Addendum #	2	Date Issued	10-25-2024
Project Name Job #	DSU Woods Hall Improvements - Phase 2		20233600
Bid Date Time	November 20, 2024		2 pm MDT

THIS ADDENDUM AMENDS AND BECOMES PART OF THE CONTRACT DOCUMENTS FOR EAPC PROJECT 20233600 DATED 1-16-2024. EACH BIDDER SHALL ACKNOWLEDGE RECEIPT OF THIS ADDENDUM BY MARKING THE ADDENDUM NUMBER AND DATE ON THE BID FORM.

M0.2

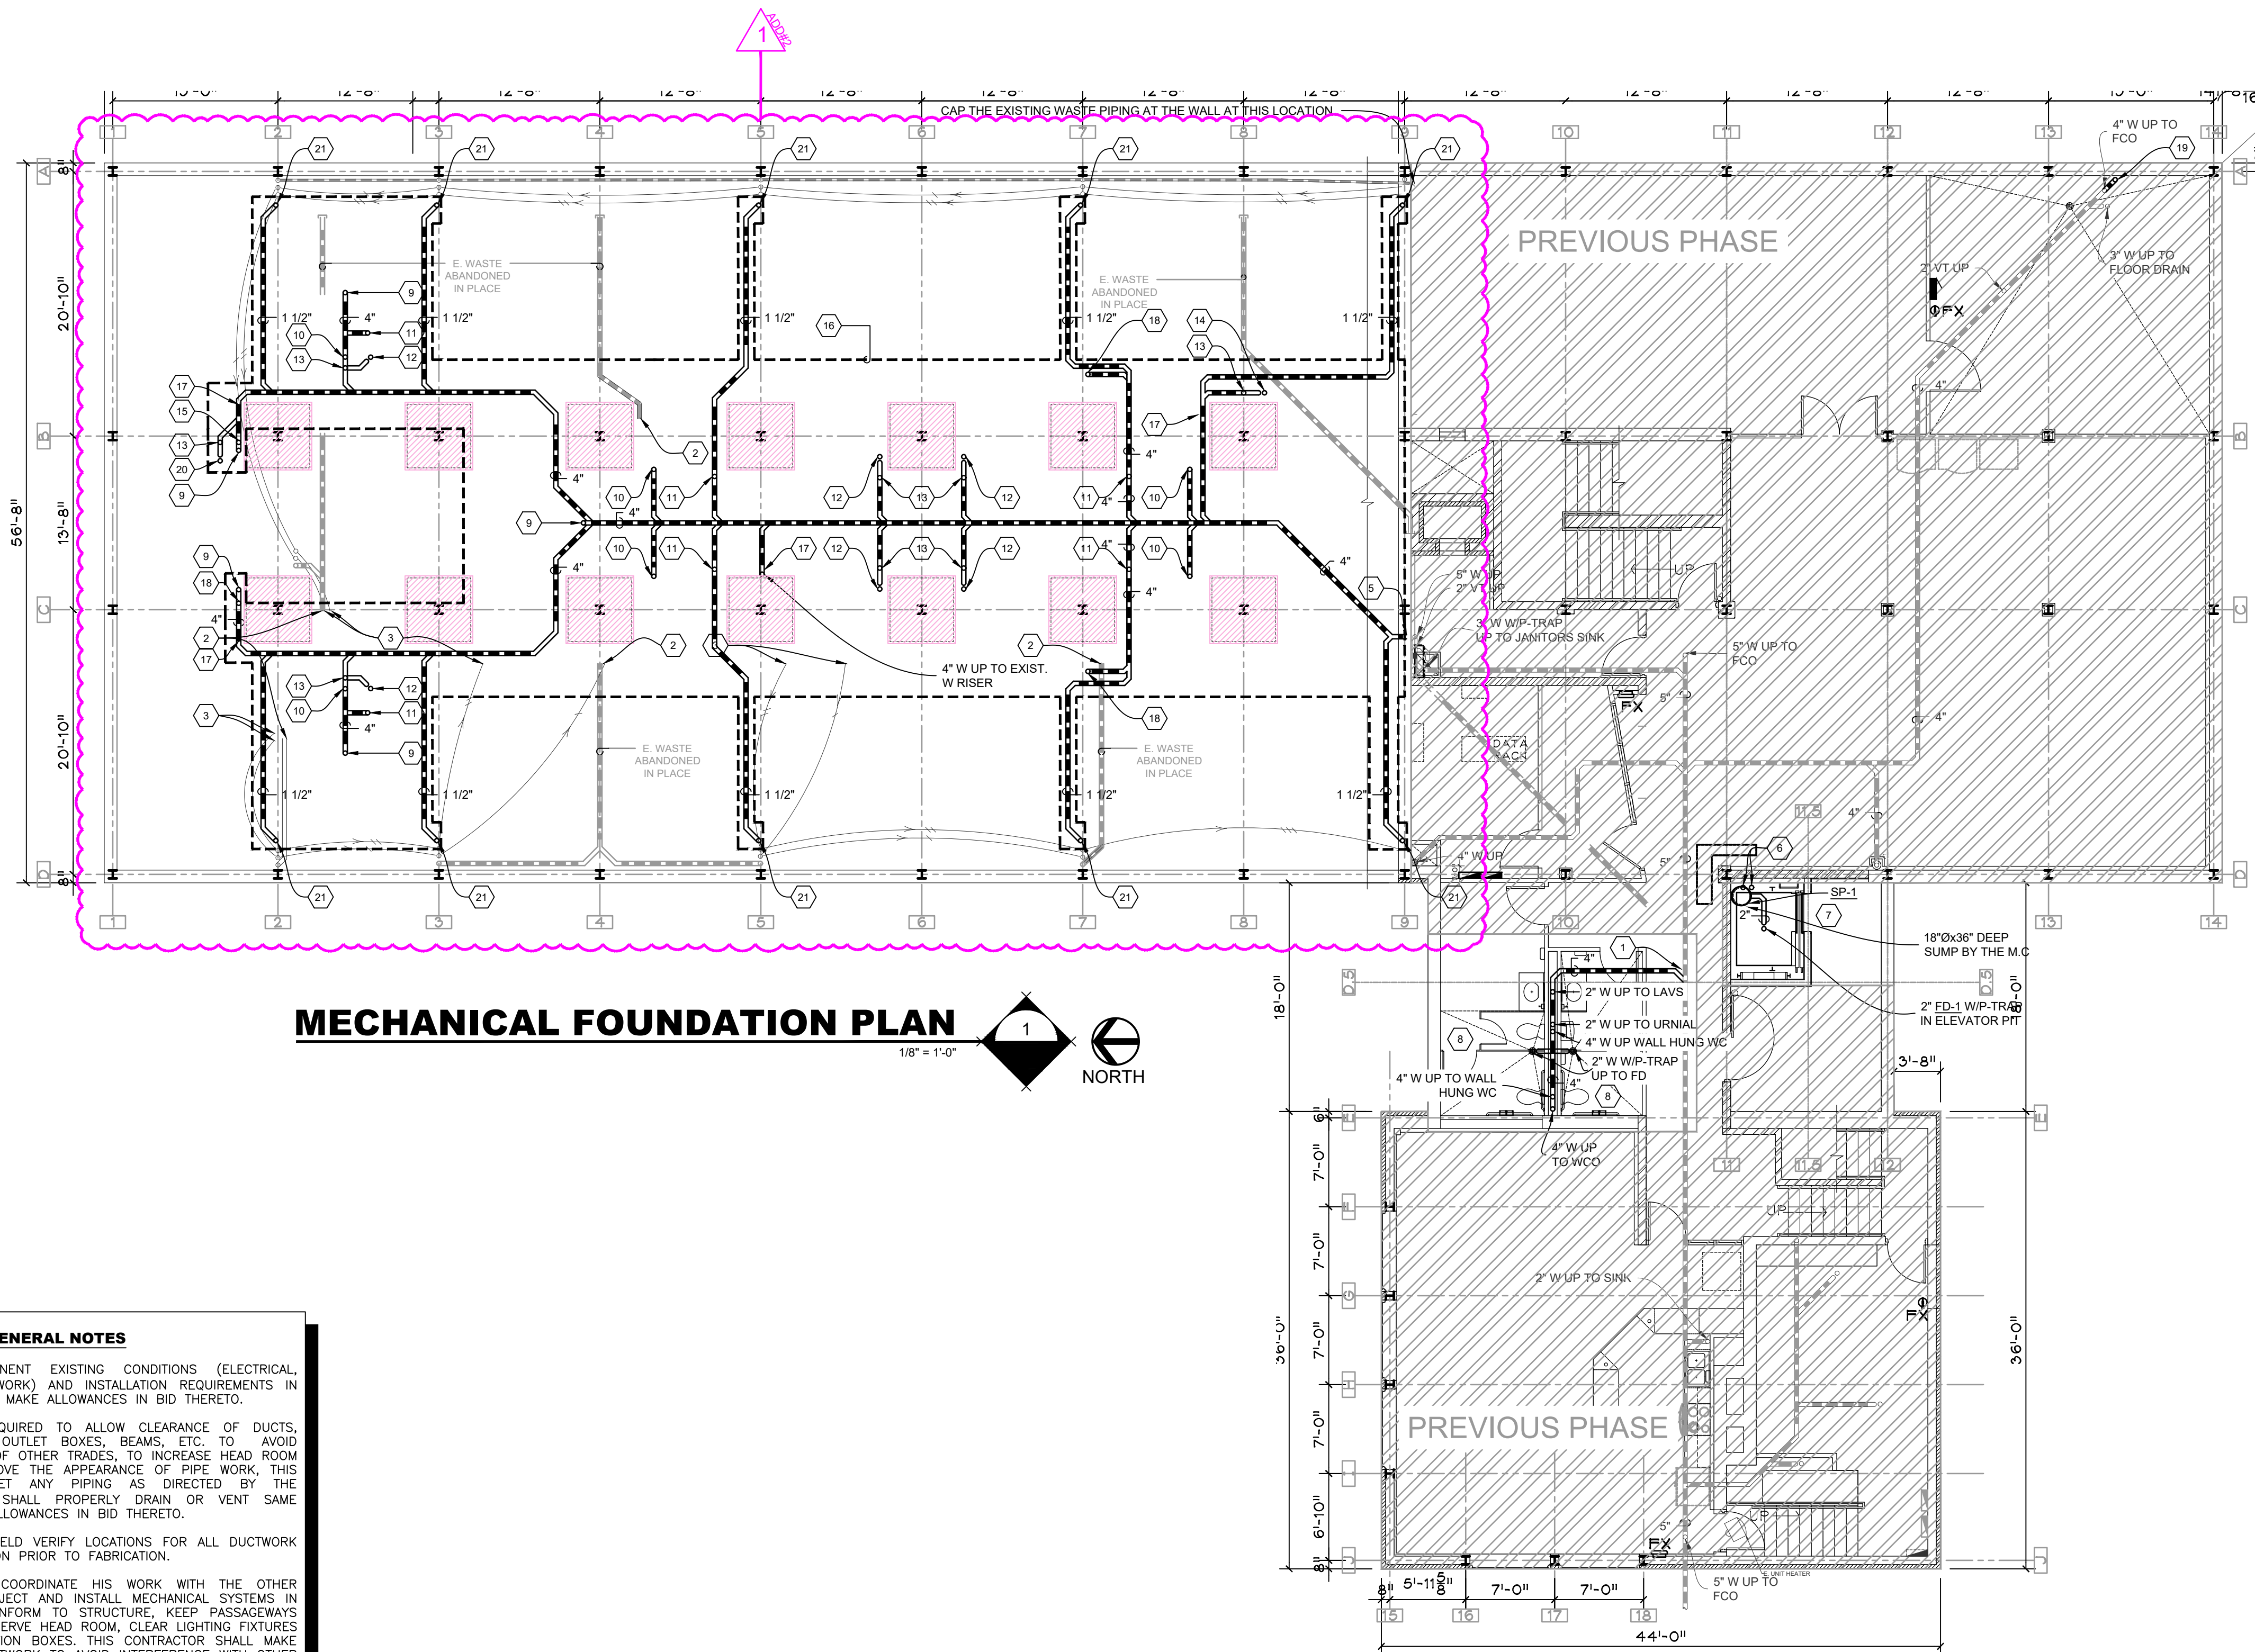
- a. Updated the drawing to add below grade waste piping to serve the mini-split A/C units on third floor.
- b. Updated and added keynotes.

P1.0

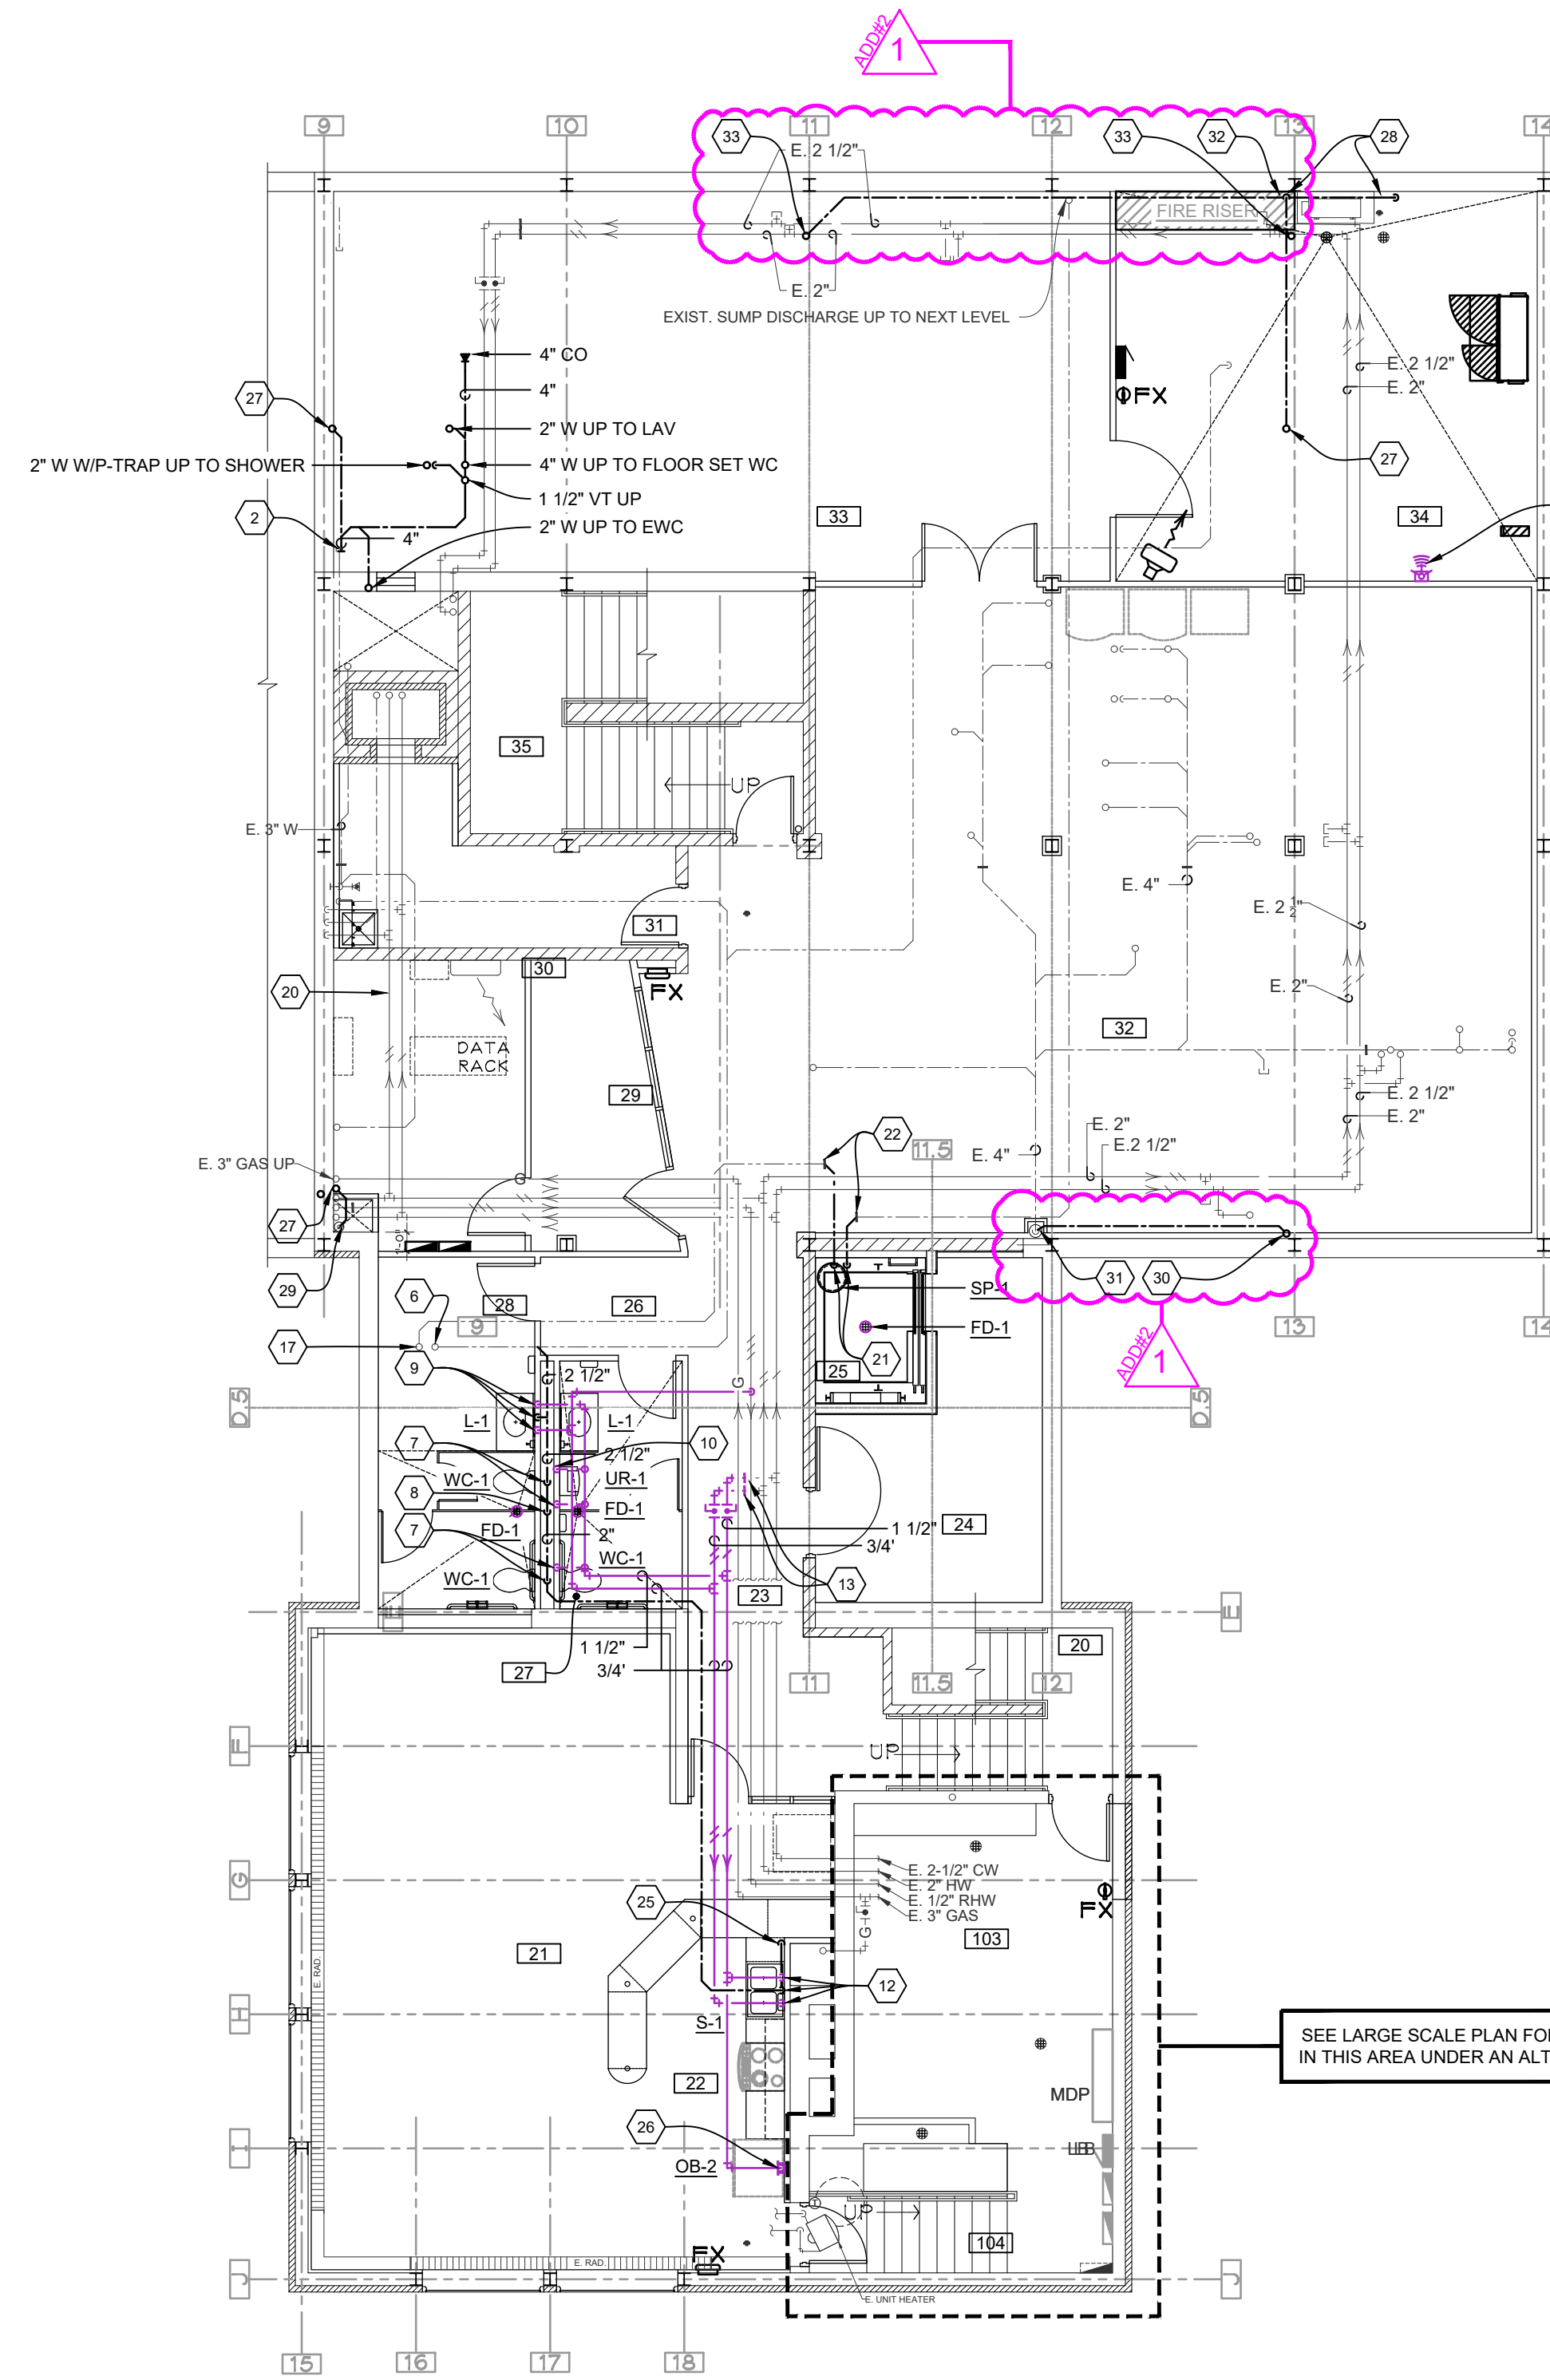
- a. Update the drawing to add waste piping connection in the basement to serve the mini-split A/C units on third floor.
- b. Updated and added keynotes.

DRAWING TITLE
MAIN FLOOR DOMESTIC PIPING PLAN

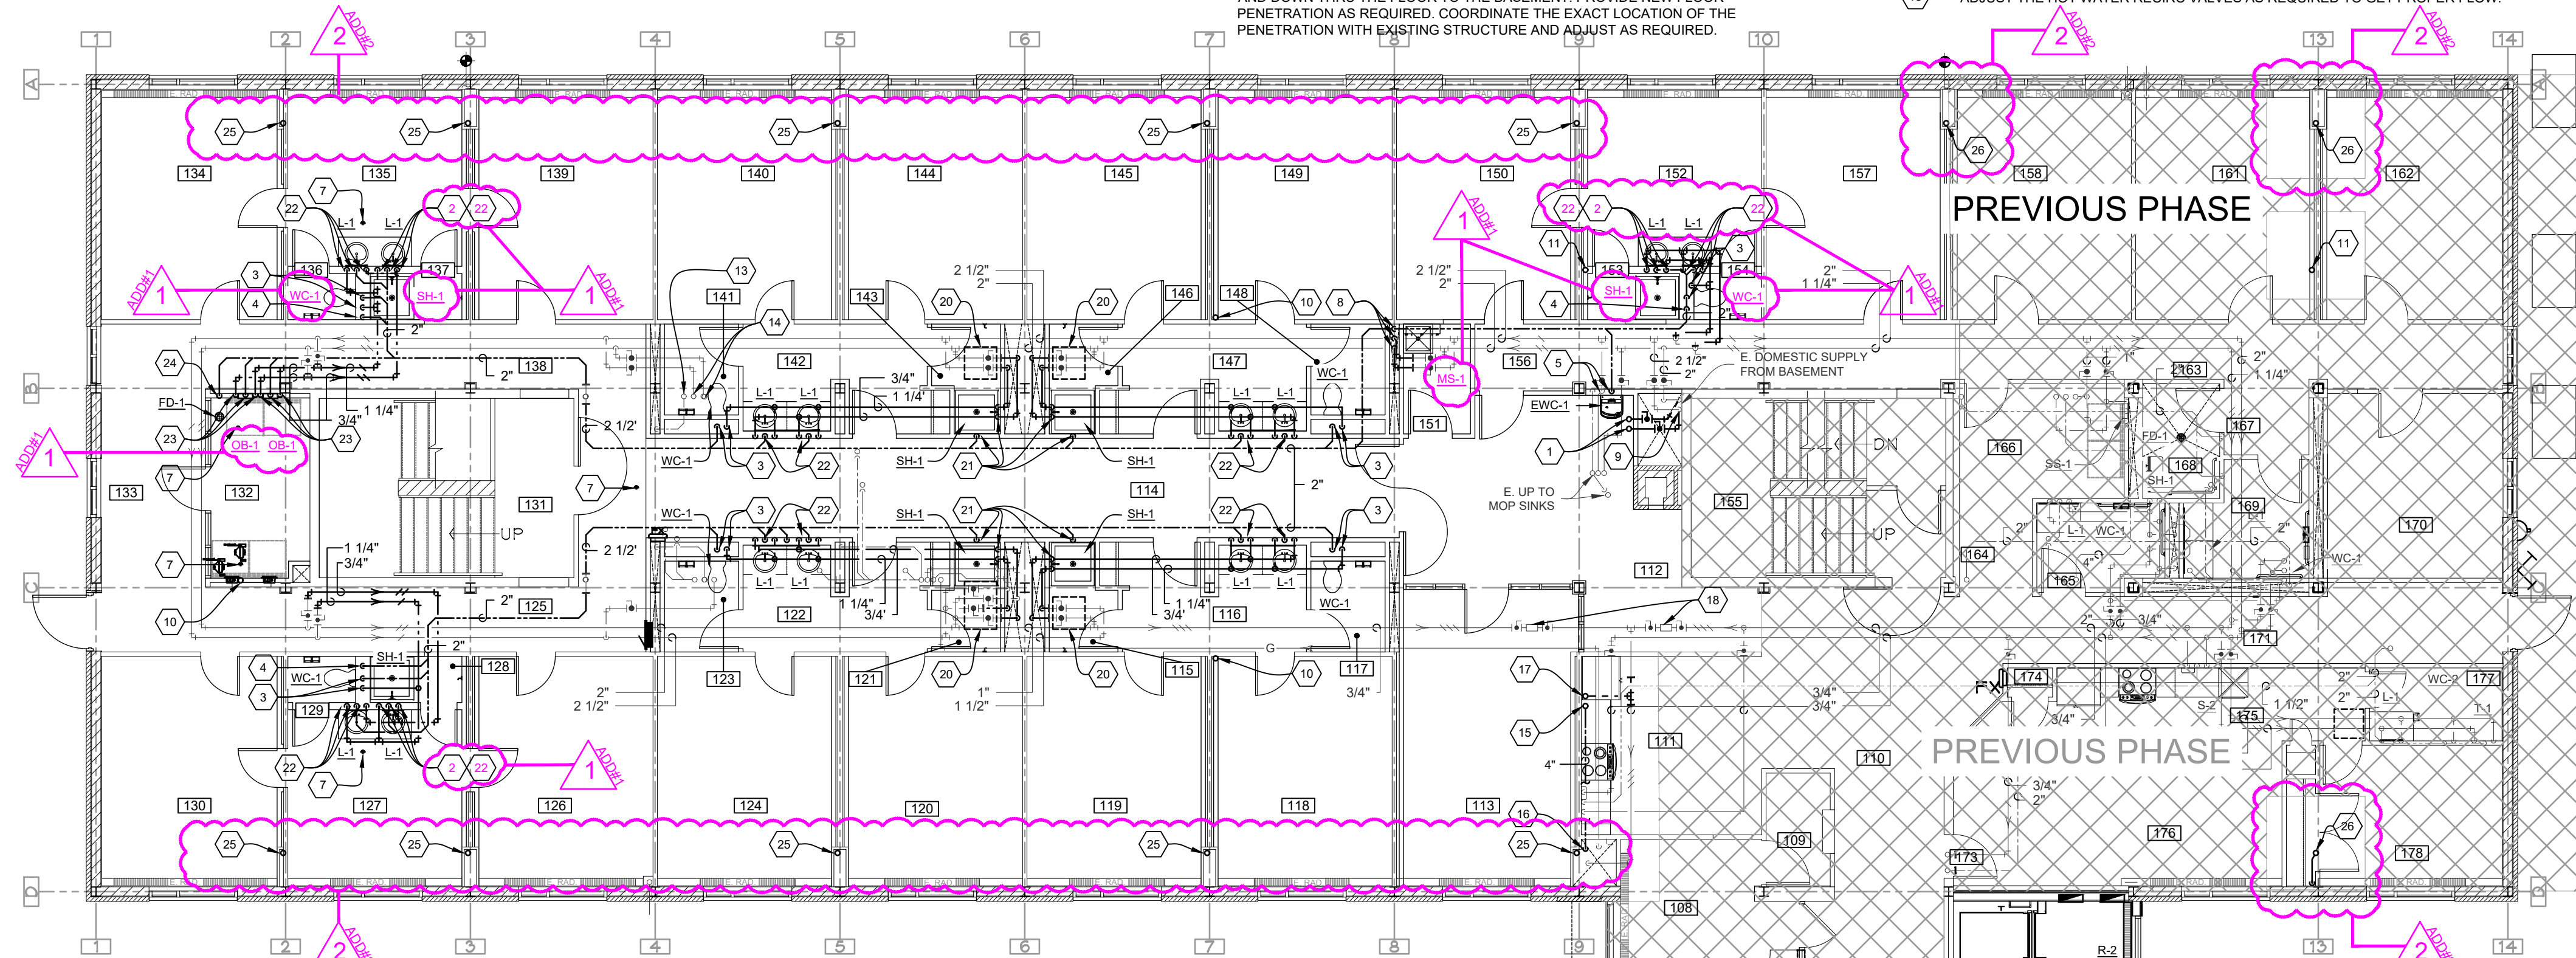
- a. Added new waste piping to serve the mini-split A/C units on third floor.
- b. Updated and added keynotes.
